Hanley Co
AS Howren's SK & Explanation
in re, to unsurveyed school
Land North of Block 2, B&B,
Filed Sep. 9, 1903,

General Land Office.

October 27, 1903.

Capt. A. S. Howren,
State Surveyor,
Channing, Hartley Co., Texas.

Hartley Co.
Sketch File #10
Outline of Dallas
& Hartley Cos.

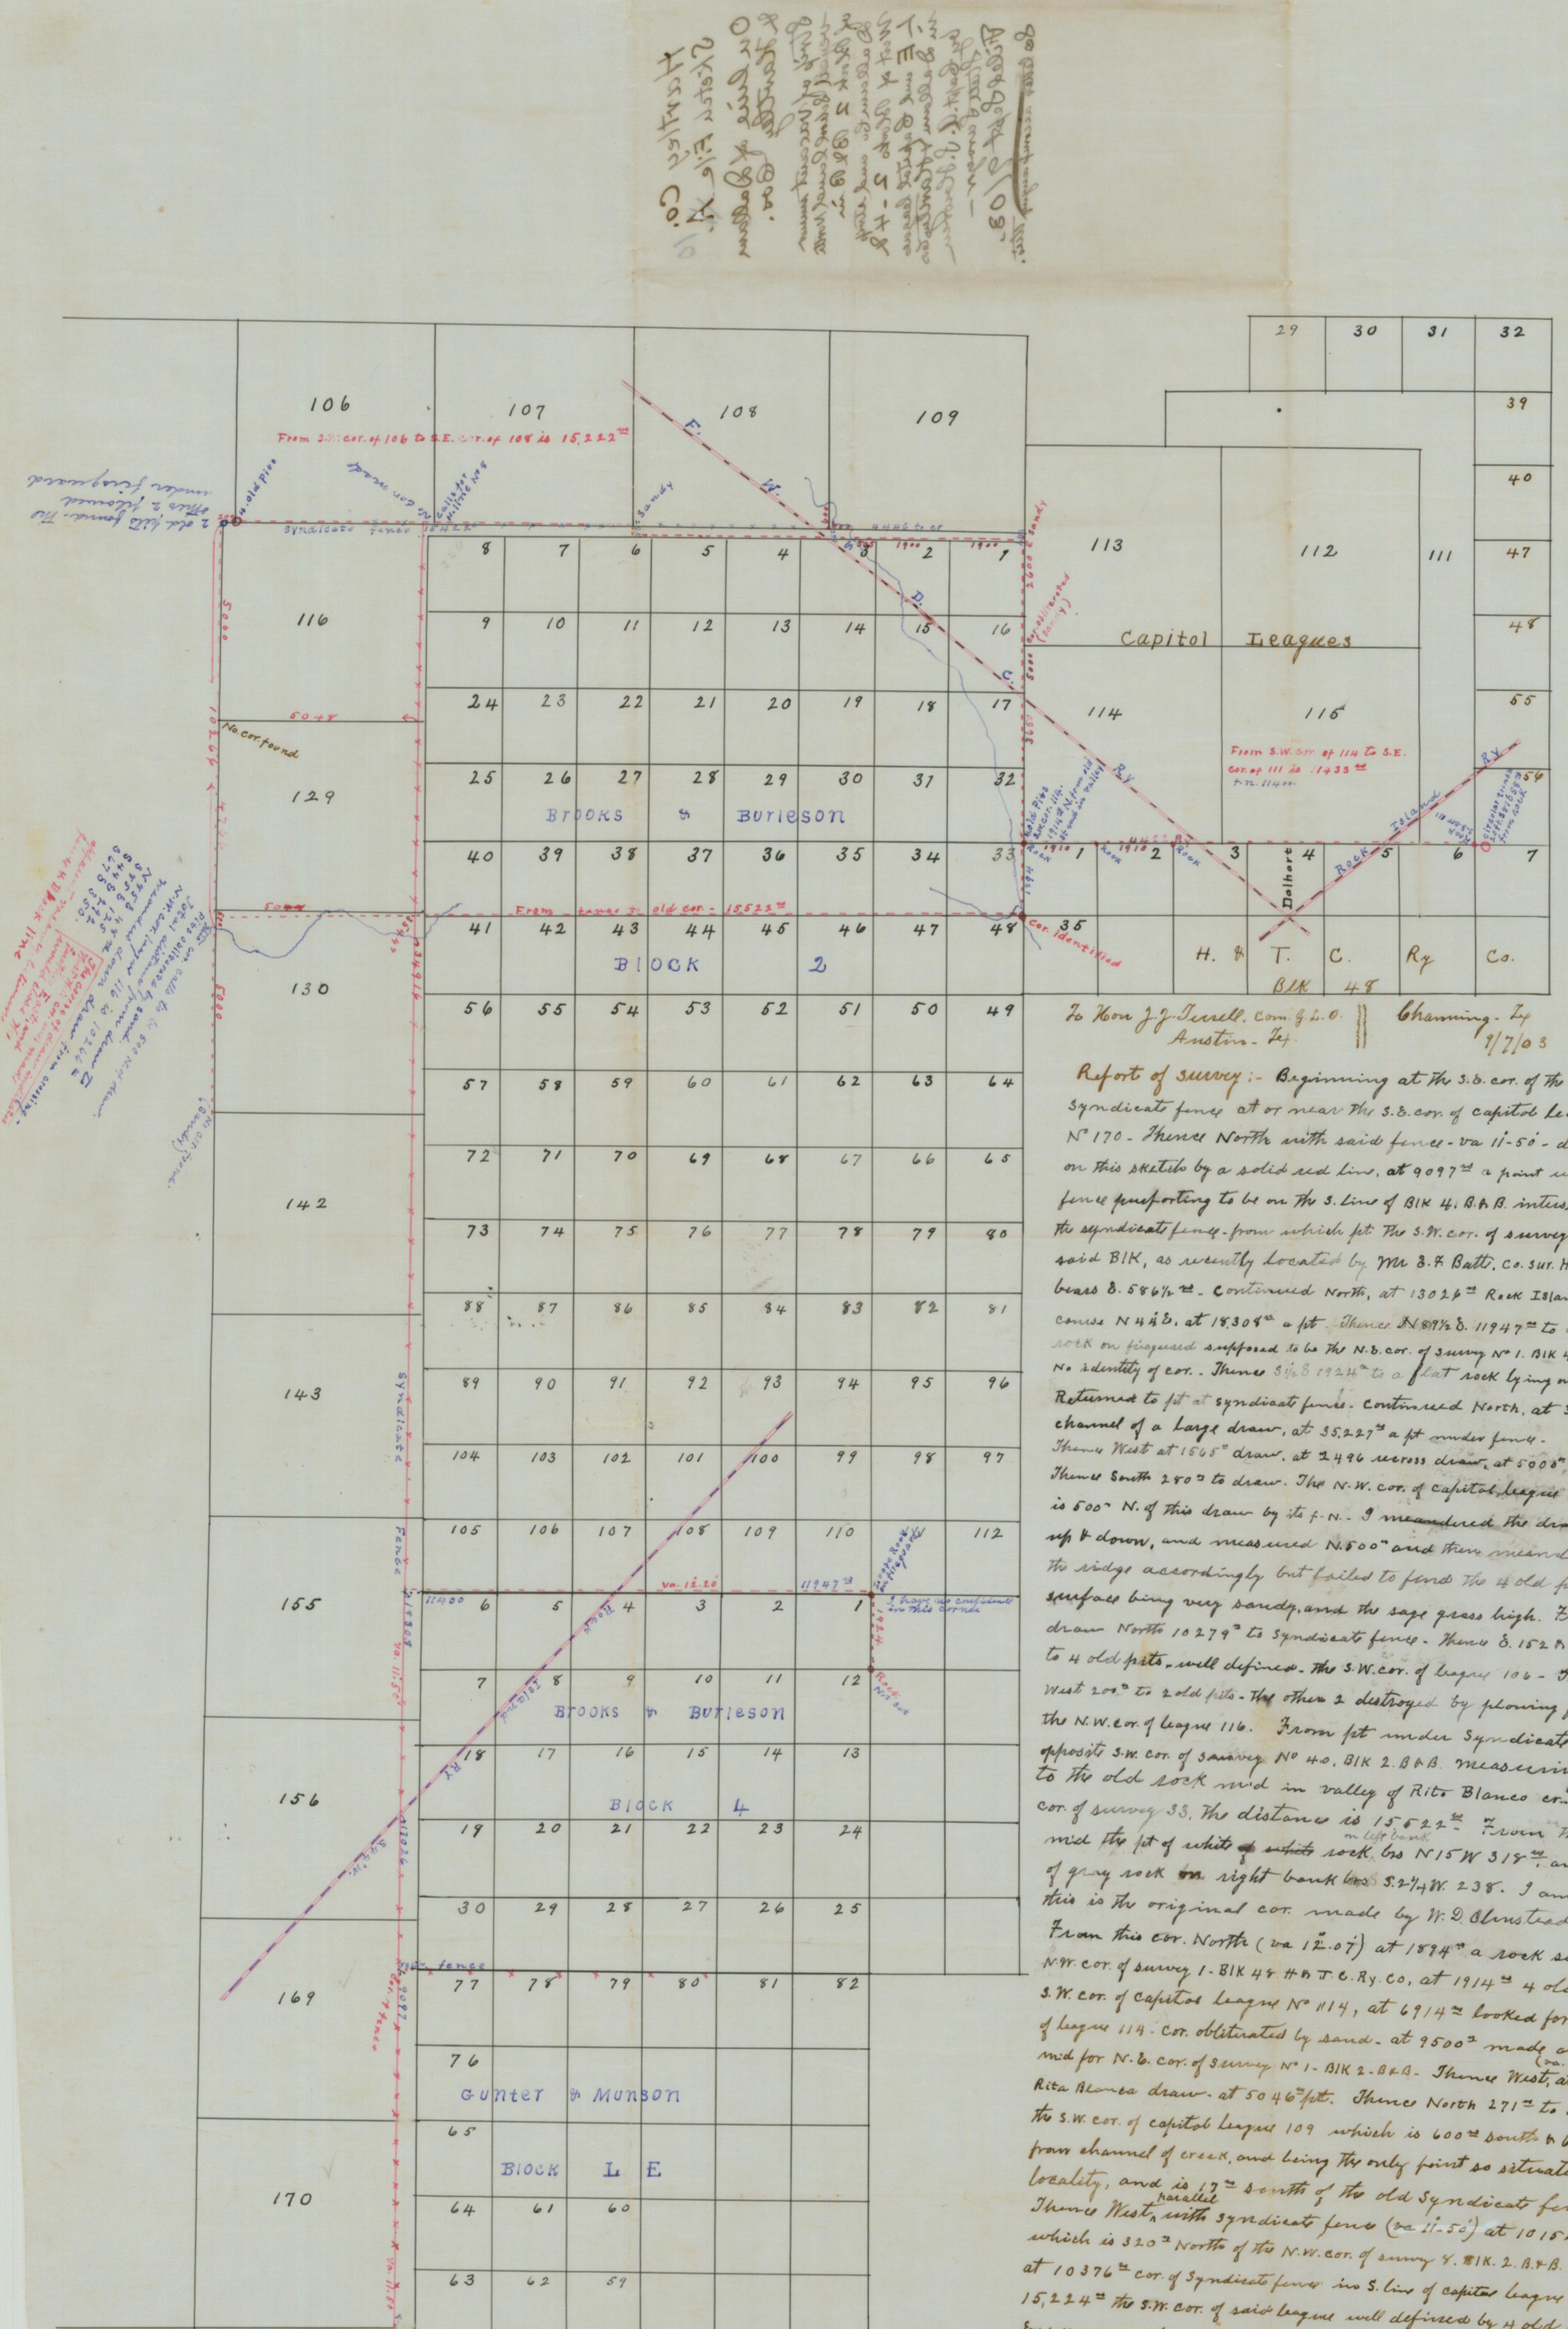
Your favor of the 7th ult. was duly received, together with elaborate sketch of connections between Capitol leagues No. 106 to 116 &c. and S. W. corner Section 1, block 48 H. & T.C.R.R.Co. in Dallam and Hartley counties. After a careful investigation of the field notes of the adjacent surveys, together with your connections and letter of explanation, I beg to report as follows: 1st. You find an excess of 222 vrs. from the S.W. corner of league No. 106 to S.E. corner of league 108. You state "if this excess be distributed between the leagues 106, 107 and 108 the South line of league 106 will be 5074 vrs. and its S.E. corner will be 320 vrs. North and 4 vrs. East of the N.W. corner of survey #8, Block 2, B. & B." Again "if league 116 is made to begin at a point 200 vrs. West from the S.E. corner of league 106, then there would be a strip of land 218 vrs. wide between the N.W. corner of survey #8 block 2, and the East line of Capitol league #116."

I will have to differ with you as to the distribution of this 222 vrs. excess, giving No. 106, 74 vrs. excess, in the absence of the identification of S.W. corner of #108, the excess would fall in league #108, and leagues #106 and 107 would simply be entitled to course and distance of 5000 vrs. each.

Now as to the beginning of league #116, it should begin 200 vrs. West of the S.E. corner of 106, or 4800 vrs. East of the S.W. corner of 106, or by reversing, that is, beginning at its original N.W. corner 200 vrs. West of the S.W. corner of #106, thence East 5000 vrs. &c., leaving a vacant strip of 268 vrs. between the N.W.

Capt.A.S.H. #2.
corner of No. 8, block 2, and the East line of league 116. You say
extending South, this strip widens at the rate of $9 \frac{1}{10}$ vrs. per
mile on account of 17 minutes difference in magnetic variation,
would be 486 vrs. at the S.E.corner of league No. 170, as against
670 vrs. by Mr. E. F. Batte.

The calls in the field notes of league 116 and the other
leagues situated South to league #156, for the West line of blocks
2 and 4, cannot be regarded as the position of the West line of
said blocks were not known, nor established, hence can only be
considered as an open call.

The S. E. corner of league No. 170 sh ould first be
correctly located. You state "Beginning at the S.E.corner of the
Syndicate fence at or near the S.E.corner of Capitol league No.170",
the fence may be on the line. I would suggest that you go to
league No. 174 in Hartley county. It has the N.W., N.E., and S.E.
corner described, and calls for crossing of creeks and roads. You
could begin at its N.E.corner, thence East, corners are called for
at every 5000 vrs. to N.W.corner of #170, thence South to S.W.corner
of #170; they all describe a mound and 4 pits for corner.

To determine the correct East boundary line of each
league, if possible, you should try and find the tier of mounds
and 4 pits from S.W. corner of league #170, North to N.W.corner of
No. 116, as these corners may be out of line.

The vacancy North of Block 2, B. & B. and South of Capitol
leagues 107, 108, and 109, is O.K. Many thanks for the information.
Very respectfully,
